CNL-22-027

Subject: **Nuclear Quality Assurance Plan, TVA-NQA-PLN89-A, Revision 40 -  
Annual Update and Proposed Changes to Revision 40**

The proposed change involves removal of all Bellefonte Nuclear Plant (BLN)-related information. On October 1, 2021, the BLN construction permits expired, and TVA is no longer a Nuclear Regulatory Commission (NRC) licensee with respect to the Bellefonte site. At the NRC's request, TVA is submitting this proposed editorial change for approval prior to implementation pursuant to 10 CFR 50.54(a)(4). Enclosure 3 provides a description of and justification for the proposed changes. The proposed changes are shown in Enclosure 4 as a marked-up copy of the applicable sections of the current NQAP, Revision 40.

Description and Justification of Proposed NQAP Changes

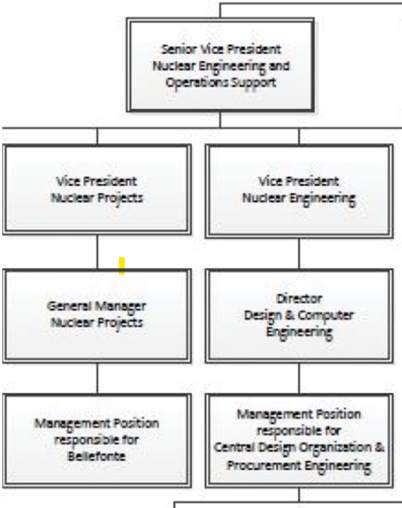
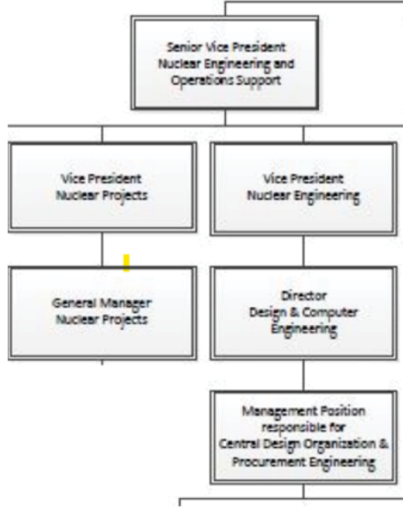
Section / Para.	Original Text	Revised Text
Appendix I	 <pre> graph TD     A[Senior Vice President Nuclear Engineering and Operations Support] --&gt; B[Vice President Nuclear Projects]     A --&gt; C[Vice President Nuclear Engineering]     B --&gt; D[General Manager Nuclear Projects]     C --&gt; E[Director Design &amp; Computer Engineering]     D --&gt; F[Management Position responsible for Bellefonte]     E --&gt; G[Management Position responsible for Central Design Organization &amp; Procurement Engineering]             </pre>	 <pre> graph TD     A[Senior Vice President Nuclear Engineering and Operations Support] --&gt; B[Vice President Nuclear Projects]     A --&gt; C[Vice President Nuclear Engineering]     B --&gt; D[General Manager Nuclear Projects]     C --&gt; E[Director Design &amp; Computer Engineering]     E --&gt; F[Management Position responsible for Central Design Organization &amp; Procurement Engineering]             </pre>

- Removal of Bellefonte. This proposed change removes references to the Bellefonte nuclear construction project from the American National Standards Institute (ANSI) N45.2-based TVA Nuclear Quality Plan following the expiration of the Bellefonte NRC Construction Permits. 10 CFR 50 Appendix B is not applicable to sites without an active or deferred Construction Permit. The revised Quality Assurance (QA) program will continue to meet the criteria of 10 CFR 50 Appendix B and other previously accepted QA program commitments for the remaining TVA Nuclear sites.
